Product Improvement Campaign

No: C1005510

Customer Confidence Program C1005510 - DUONIC Transmissions Below Serial # ZF31446

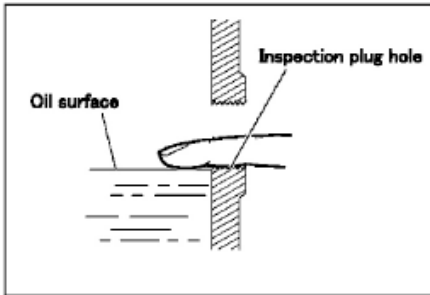
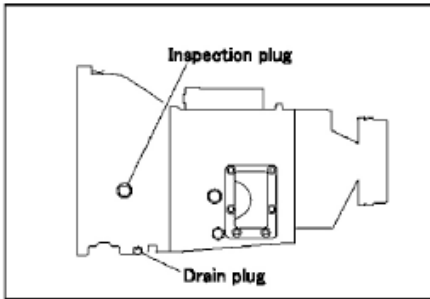
As an important part of the Fuso Customer Confidence Program, the DUONIC transmission assembly will be replaced with an updated assembly.

The DUONIC transmission serial number and ATF level in the front reservoir must first be inspected. If the serial number is below **ZF31446**, follow the instructions in this bulletin to replace transmission assembly. The transmission assembly will be replaced to prevent front seal leaks and/or excessive gear noise. If the serial number is above **ZF31446**, follow the instructions in bulletin C1005320.

Updated DUONIC transmission assemblies must be ordered through Fusonet using the DUONIC Transmission Order Form found under the Parts tab. MFTA Parts will ship part number **ME539591XN** for unsold FE vehicles (stock units), **ME539591XR** for sold FE vehicles, **ME539597XN** for unsold FG vehicles and **ME539597XR** for sold FG vehicles. **Please Note: Updated transmissions ending in "XR" are units that have been removed from sold trucks and updated by the rebuilder. Since federal law prohibits installing used components in new vehicles, Dealers are prohibited from installing an ME539591XR or ME539597XR transmission assembly in any unsold vehicle. Assemblies ending in "XN" are updated new transmissions that must be used on unsold trucks.**
